Expanded Community Advisory Panel (XCAP)

THIS PACKET INCLUDES:

A compilation of emails (public comments, etc) submitted to the XCAP email box, XCAP@CityofPaloAlto.org, between **May 21 and June 3, 2020 at 12:00 pm (noon)**.

Figure 3-4. Relationship between radius and cycling speed [9]

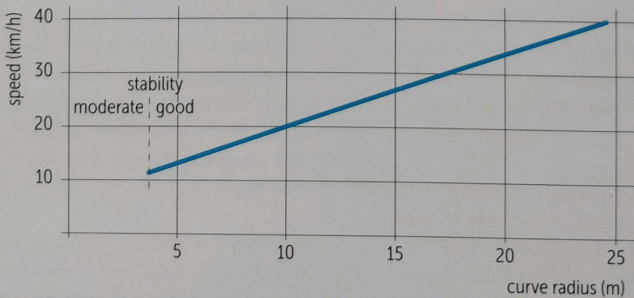
- The plot on the first page shows the turn radius of a bike as a function of speed. At the bottom of the tunnel, bikes will have picked up quite some speed (easily 30 km/h (20 mph)), so any curve would need to be bigger than about 15m (50 ft). The corner of the Kellogg Tunnel with the Embarcadero bike path has a very sharp corners which would be a bad idea.

Figure 3-5. Bandwidths for gradients [8]

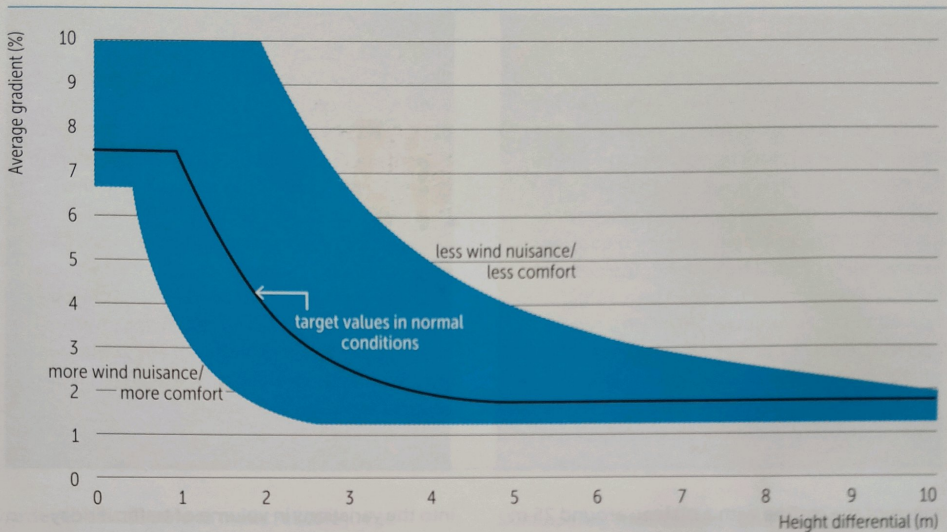
- The second page shows comfortable gradients. I could not guess the gradients from the renderings, but just something to keep in mind.
- The Netherlands is one of she safest countries to ride your bicycle, and infrastructure design is an important part of that. Two important aspects of safe design are:

Figure 6-1. The probability of a cyclist dying as a result of a collision with a passenger car as a function of the collision speed (processed by Theo Zeegers using TNO research data [2])

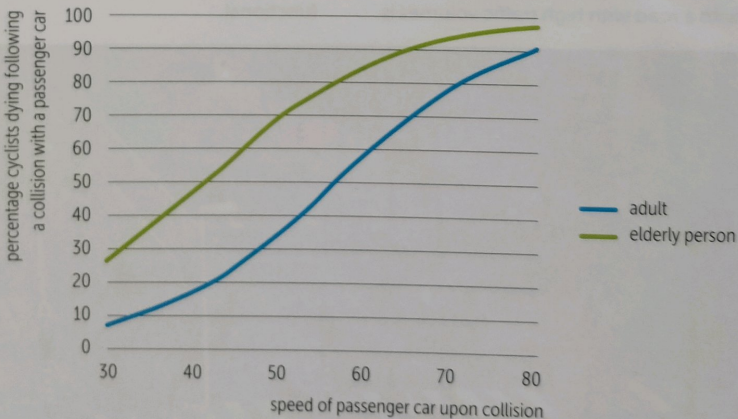
- Slow down traffic: The attached graph in the third page shows the percentage of cyclist dying in a collision with a car as function of speed. It shows that especially for elderly bike riders the outcomes of a collision are very lethal at higher speeds. Thus, much of the Dutch infrastructure design aims to slow down car traffic.

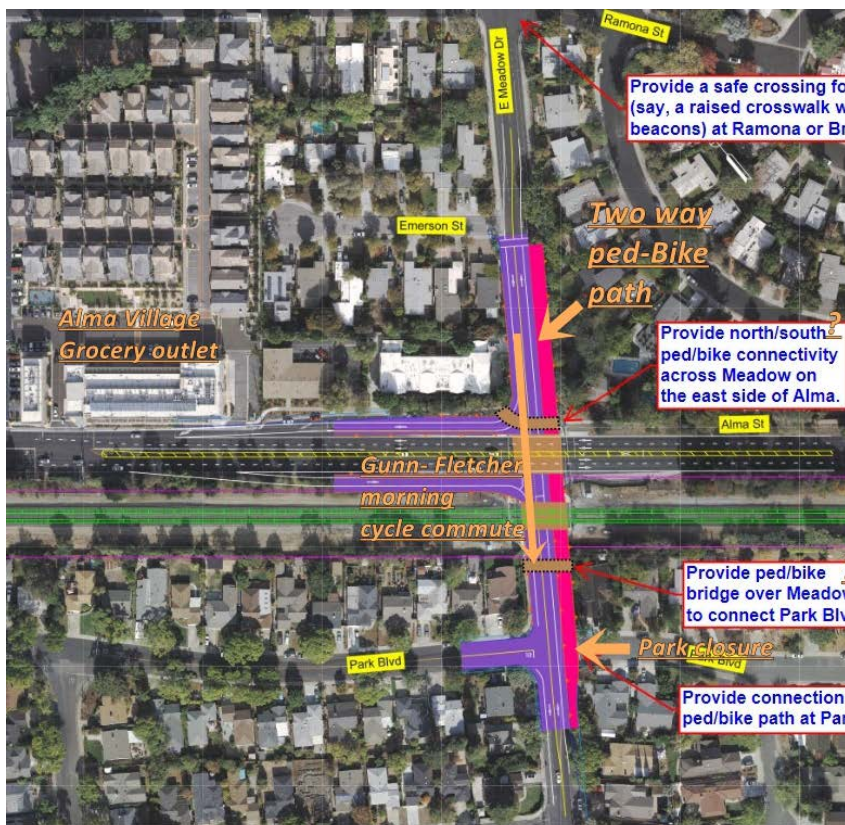
I think PABAC should have an advisory role in evaluating the various proposals for separating the rail from roadways, bikeways and sidewalks. Recent ideas have emerged. They "deeply" tunnel Meadow and Charleston under the tracks. A 20' wide two way path protected from vehicles is proposed on one side of the Meadow tunnel.

I am opposed using a ped-bike path on only one side, particularly at Meadow. I think bicycle and pedestrian safety would be increased.

Opposition to paths on only one side is informed by my service as a School Safety Crossing Guard at Meadow and Charleston intersections. Bicyclists are instructed by law to ride in the direction of vehicle traffic. The one side ped-cycle track proposed at Meadow-Alma would bring special danger to morning rush hour Gunn and Fletcher cyclists. They would have to make crossing maneuvers at entrance and exit.
